MEMORANDUM

TO: District of Columbia Zoning Commission
FROM: *JS* Jennifer Steingasser, AICP, Deputy Director, Development Review and Historic Preservation
Karen Thomas, Development Review Specialist
DATE: September 6, 2022
SUBJECT: Public Hearing Report for Zoning Commission Case No. 22-11, Consolidated Planned Unit
Development and Related Map Amendment from MU-12 to MU-10 at 807 Maine Avenue,
S.W. / Square 439-2, Lot 15

2. Lot Occupancy: 80% maximum permitted; 90.78% proposed; (Exhibit 28A1 Sheet 004)

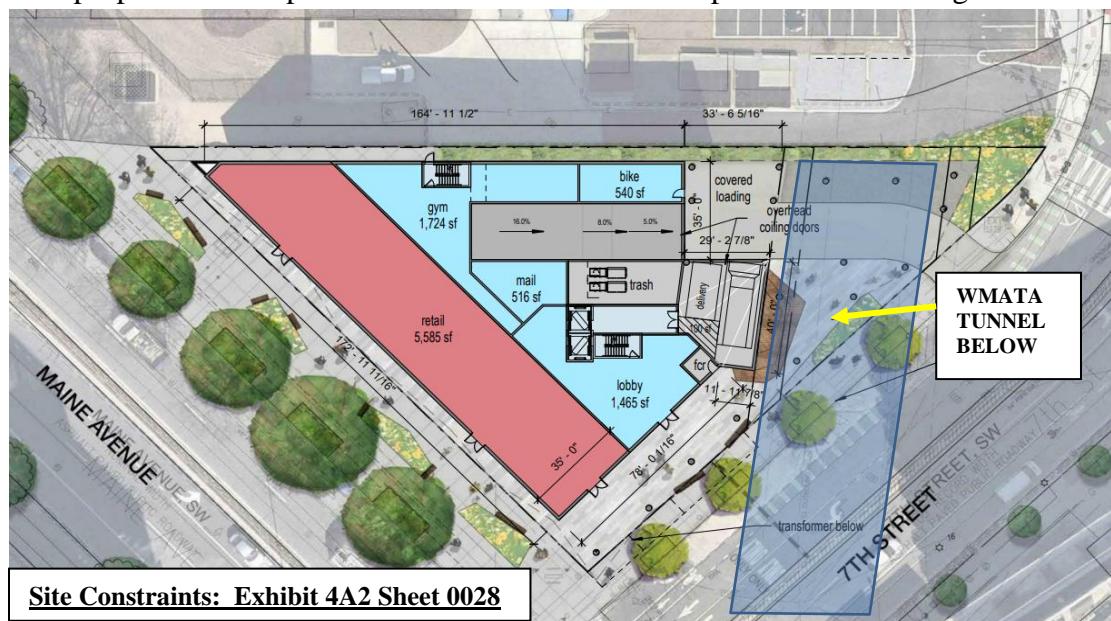
The Applicant states that the lot occupancy increase is due to the size and shape of the lot, and the provision of upper story projections. These proposed projections would allow the design above the ground level the building to be horizontally differentiated by three, three-level building forms, which in conjunction with the building corners are intended to create an “an interlocked wave that peaks visual interest at every major corner of the Project.” This design is also intended to overcome the site’s encumbrance by a WMATA easement area which result in shorter façades along the main elevations of 7th Street and Maine Avenue. (See [Exhibit 4A1 – Sheets 007,008](#) for projection views.)

OP supports this flexibility which would allow the projections to minimize the massing along the most visible elevations from public space.
